Comment Response Letter

Project Name: Pastry

Project File Number: DSRFY2023-0010

The following are updates from the previous Design Review meeting on February 5th, 2024.

PEDESTRIAN
CONNECTION
EXHIBIT

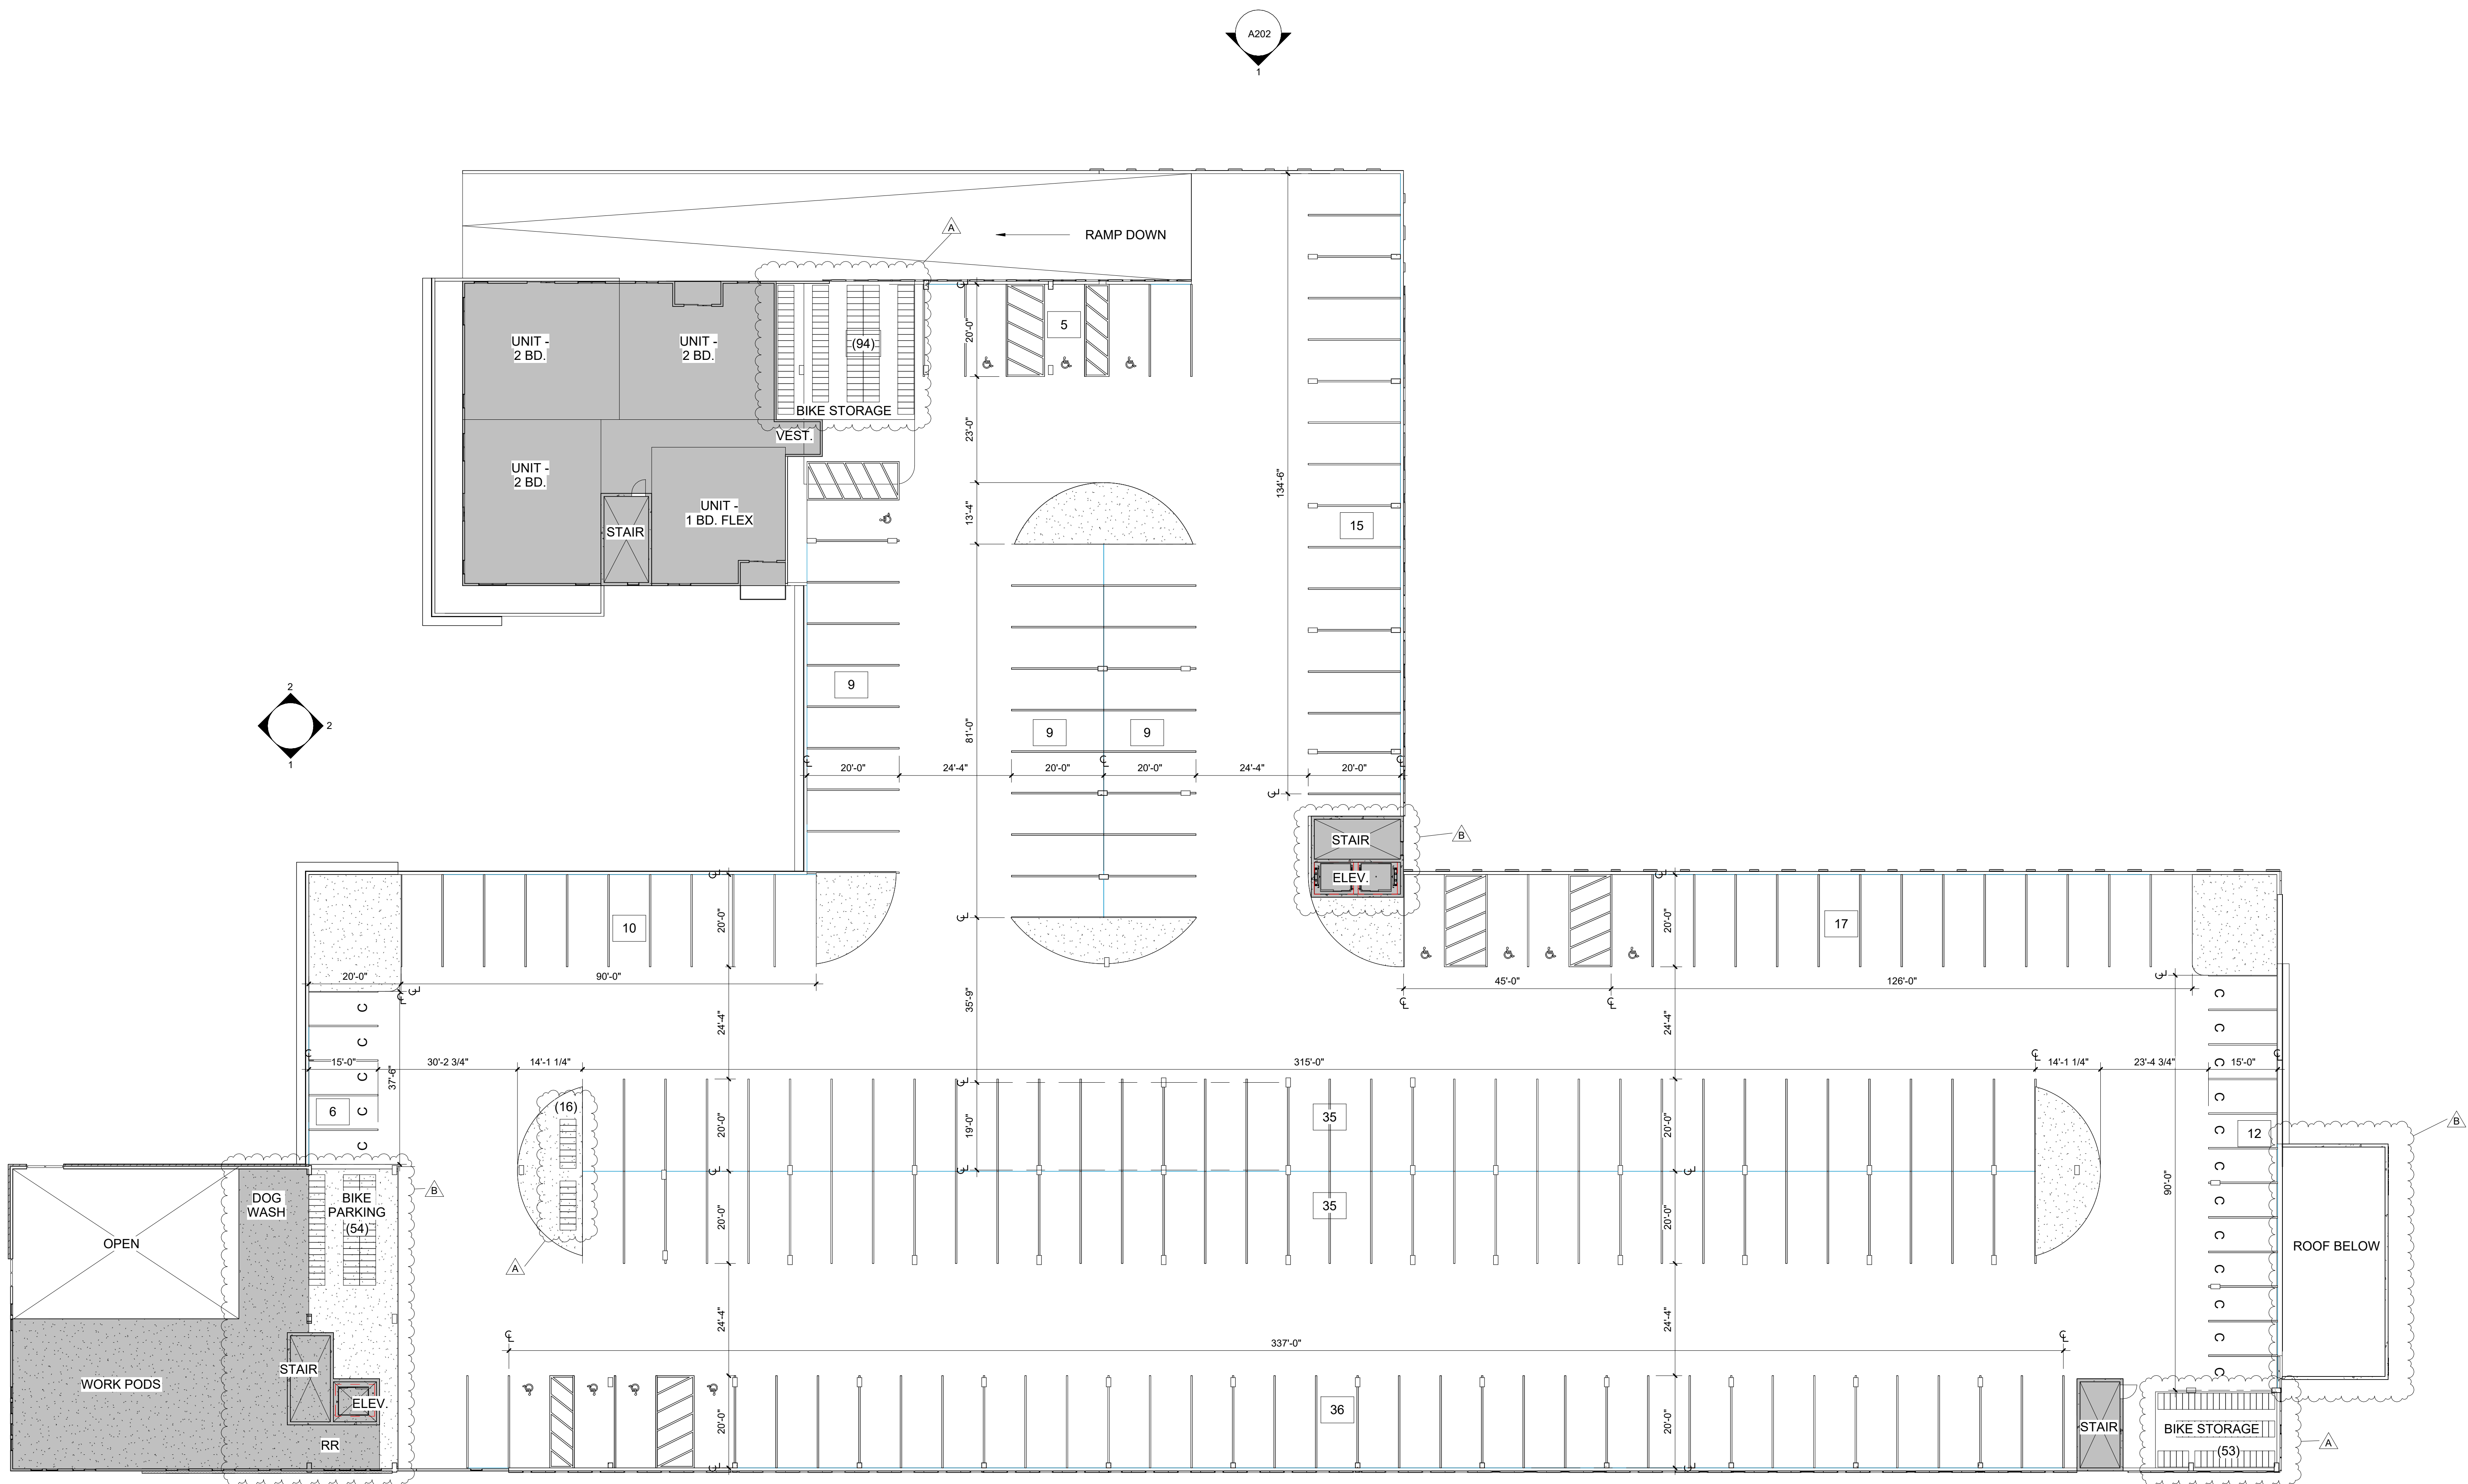
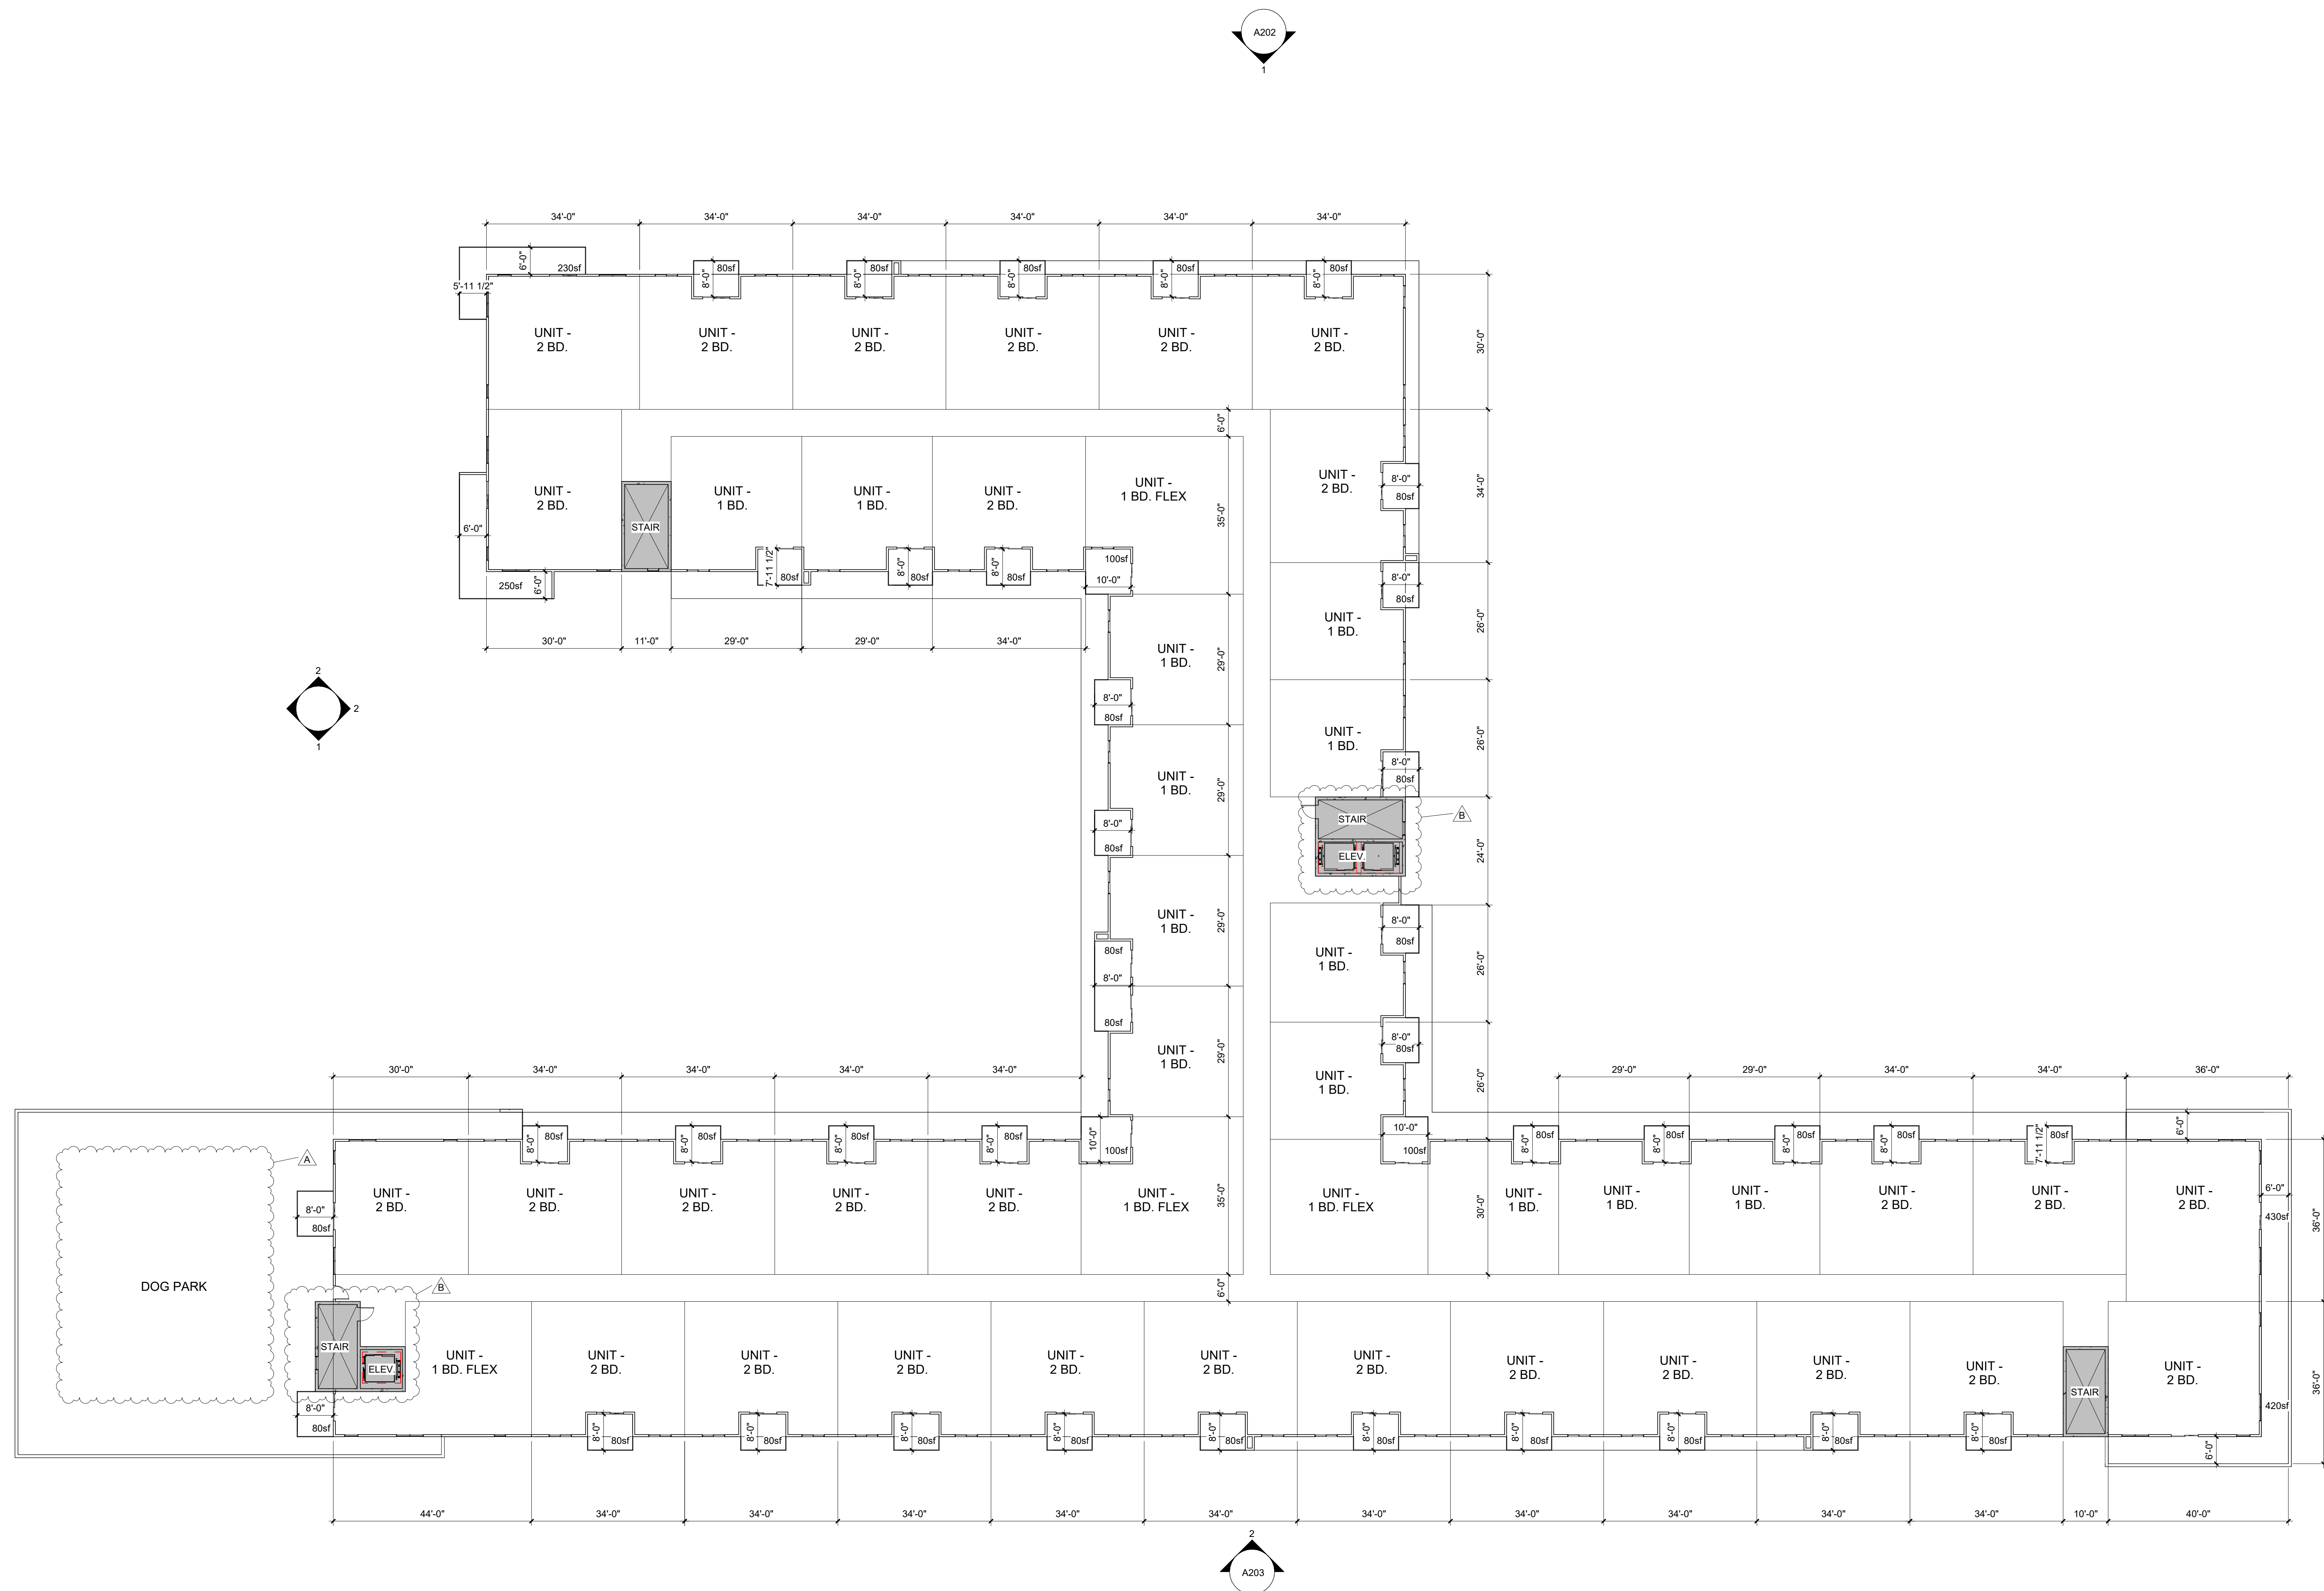
5. **Fencing.** The fencing plan was updated to provide location and types of fencing throughout the site.
6. **Pedestrian Crossings.** Direct access from the building to Glenwood Street is not provided so that pedestrians do not have to cross drive aisles to access sidewalks. The drive aisle that crossed directly in front of the building on Glenwood Street was removed. Additionally, pedestrian crossings on the west side of the building that cross drive aisles, as well as the trash enclosure area, are stamped concrete to clearly delineate those crossings.
